## **Mark-ups to COLA ER Section 2.7**

BBNPP RAI 101,  
Question 11.03-2

**Figure 2.7-92— Maximum Terrain Heights, With Respect to Finished Floor Grade, 0-5 Miles Downwind of Bell Bend by Compass Sector**

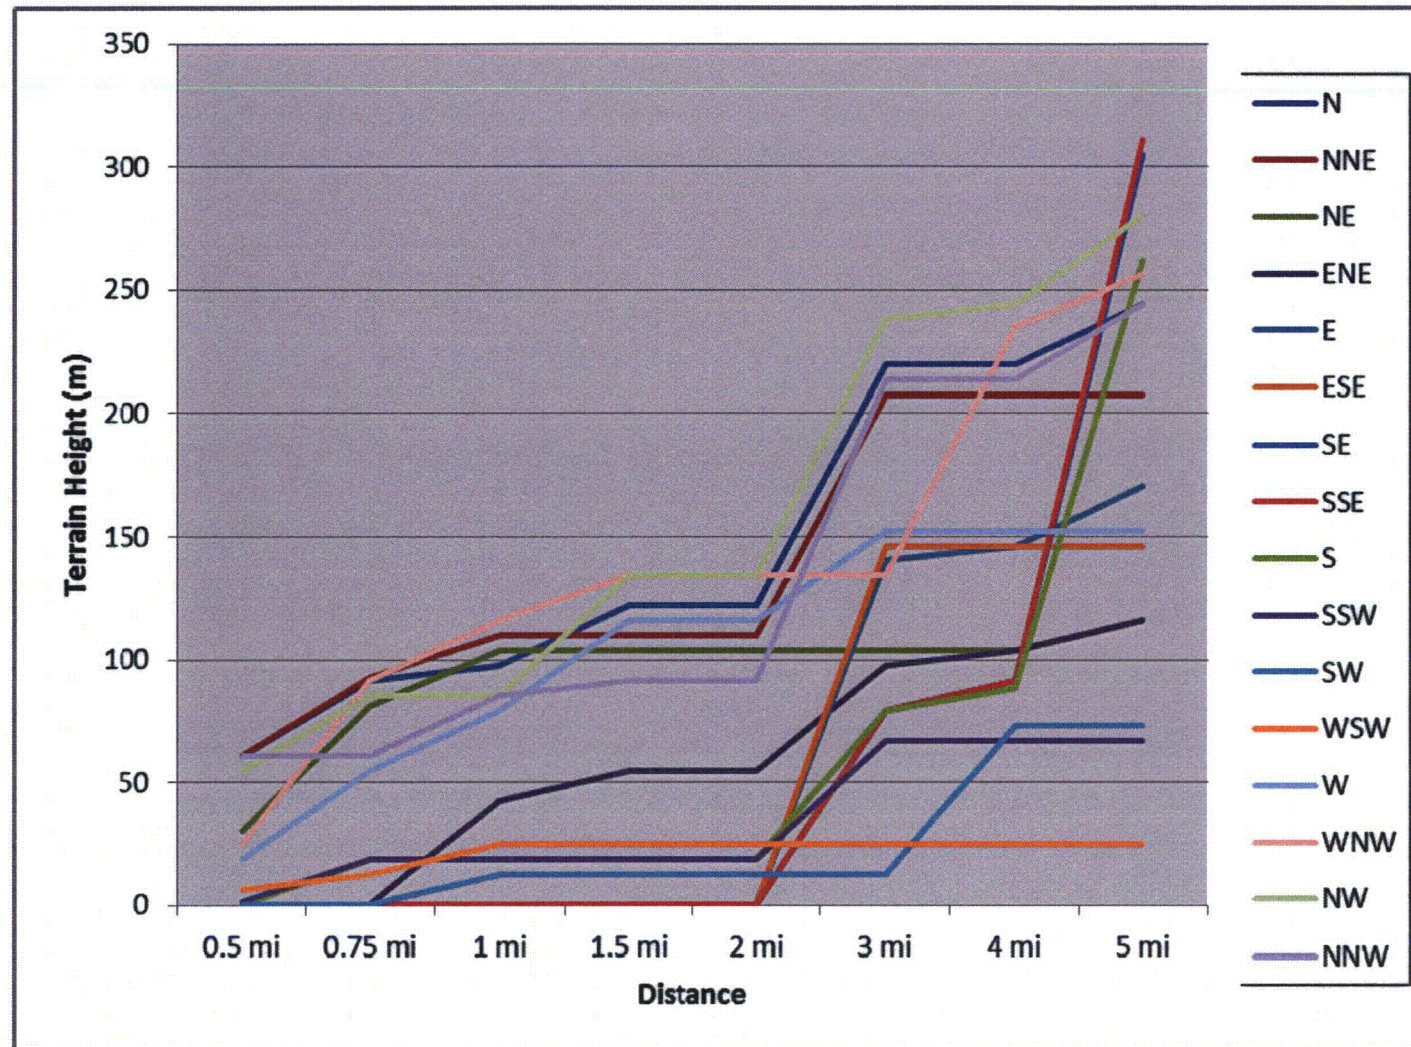
Insert P

**Figure 2.7-93— Maximum Terrain Heights, With Respect to Finished Floor Grade, 0-50 Miles Downwind of Bell Bend by Compass Sector**

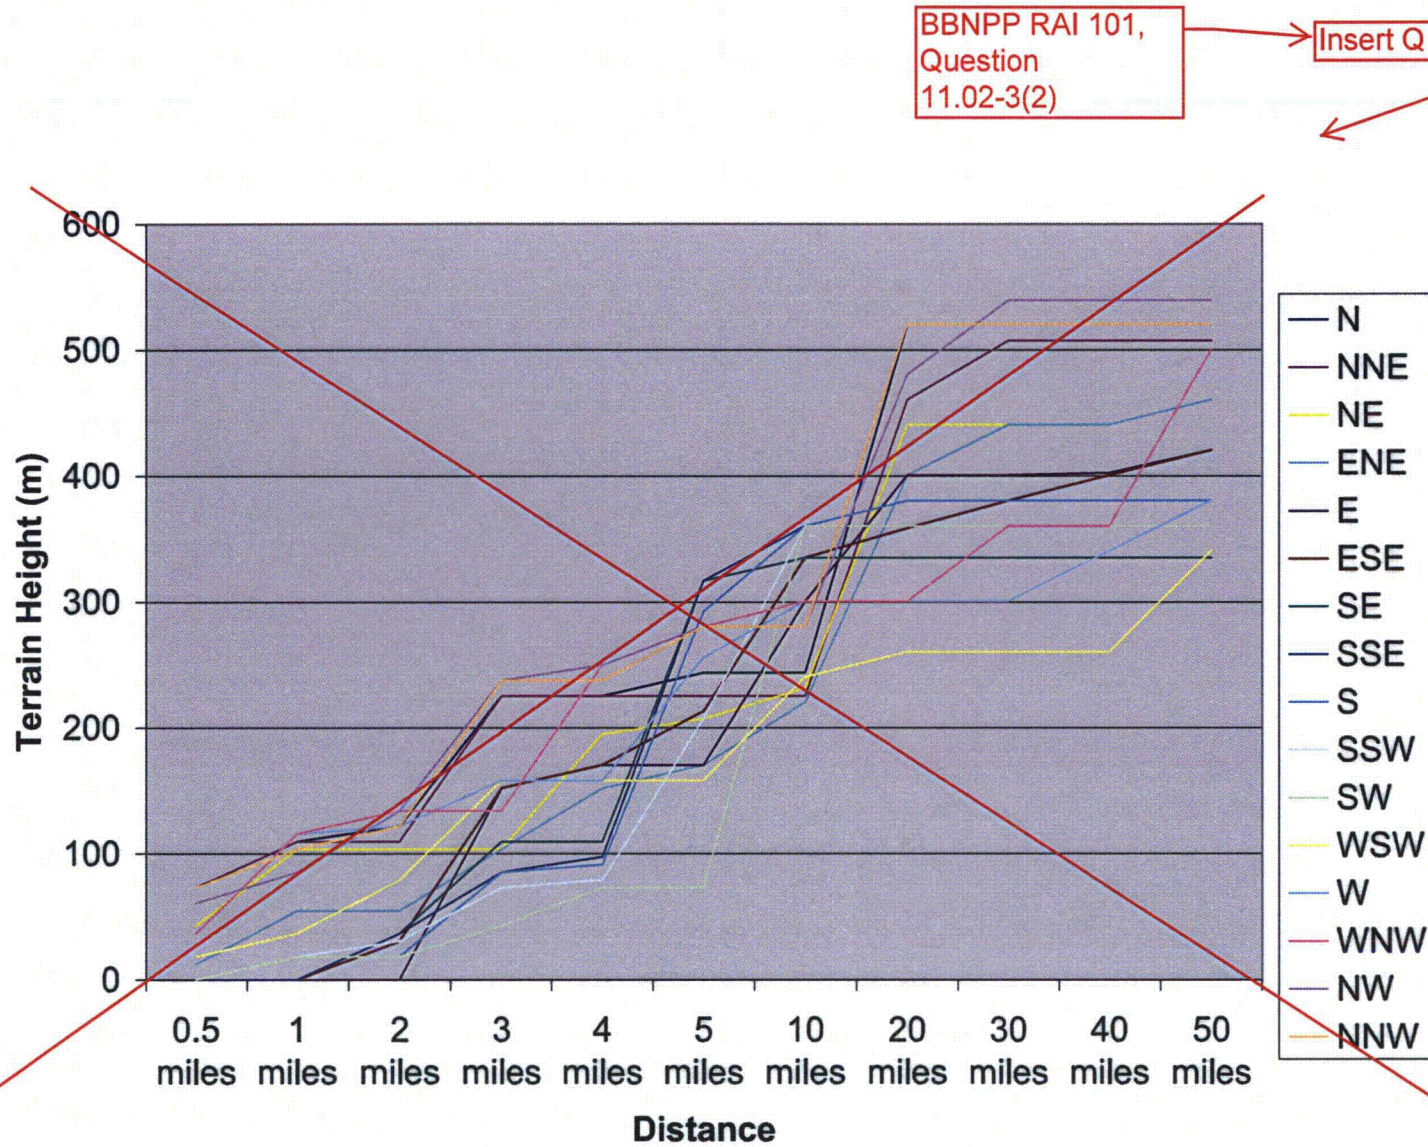
Insert Q
